SERVICE BULLETIN

No. 487

Piper Aircraft Corporation

Control Shaft Collar Attachment Modification

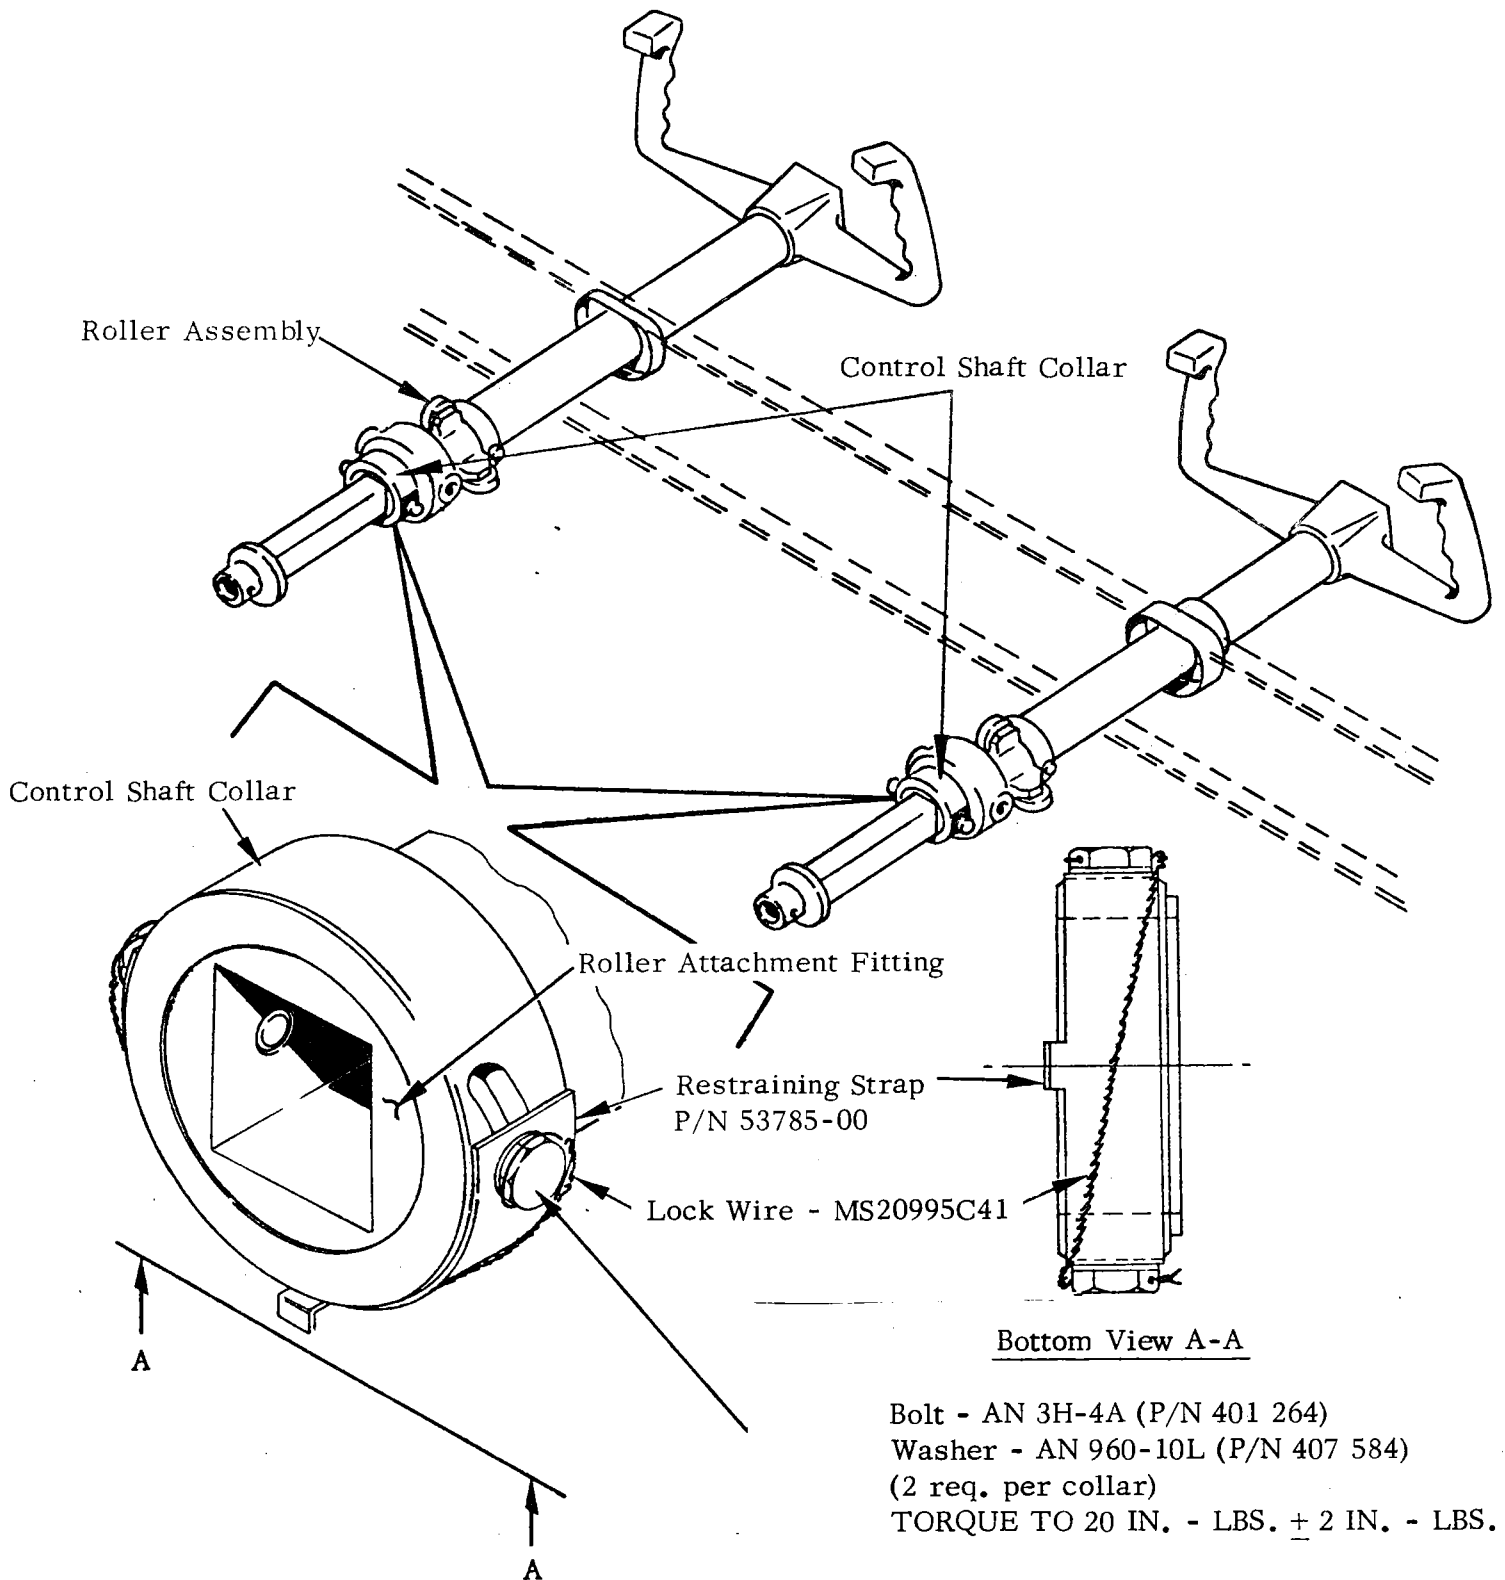
A recent report from the field indicates that the AN 3H3A bolts which attach the control shaft collar to the control shaft tube can be of insufficient length to allow proper bolt thread engagement. Should this condition exist, the bolts can become detached from the assembly, affecting control column function.

This release provides material and instructions to replace the existing control shaft collar attachment bolts with longer attachment bolts and related hardware to insure a secure attachment of the control shaft collar to the control shaft tube (refer to attached sketch for an illustrated view of the area).

1. Refer to attached sketch; move control wheel to gain access to roller assembly. Rotate control wheel as required to gain access to each bolt.
2. Cut lock wire, as shown on sketch detail.

3. Remove AN 3H3A bolt and corresponding AN 960-10 washer.

4. Install AN 3H4A bolt (Piper part number 401 264) and AN 960-10L washer (Piper part number 407 584).
 5. Using a 3/8" socket and a low-scale, inch-pound torque wrench, tighten bolt to 20 inch-pounds \pm 2 inch-pounds; if this torque value can be maintained without stripping the threads repeat steps 3, 4, and 5 on other bolt.
 - a. If 20 inch-pounds \pm 2 inch-pounds torque value cannot be maintained on either bolt, contact the factory (Lock Haven Facility) Customer Service Dept. for further information.
 6. After completion of above steps, lock-wire bolts (see sketch).
 7. Repeat steps 1 through 6 with other control wheel.
 8. Make appropriate log book entry indicating compliance with this Service Bulletin.
1. Four (4) each per aircraft AN 3H4A bolt, Piper part number 401 264;
 2. Five (5) each per aircraft AN 960-10L washer, Piper part number 407 584.

Bolt - AN 3H-4A (P/N 401 264)
 Washer - AN 960-10L (P/N 407 584)
 (2 req. per collar)
 TORQUE TO 20 IN. - LBS. \pm 2 IN. - LBS.

NOTE: Inspect to insure that the bolts are not protruding through the Roller Attachment Fitting by placing a .040 feeler gage between the fitting and the square tube. Should the bolt protrude, add one (1) additional AN 960-10L washer under the head and recheck clearance at 20 IN. - LBS. \pm 2 IN. - LBS.
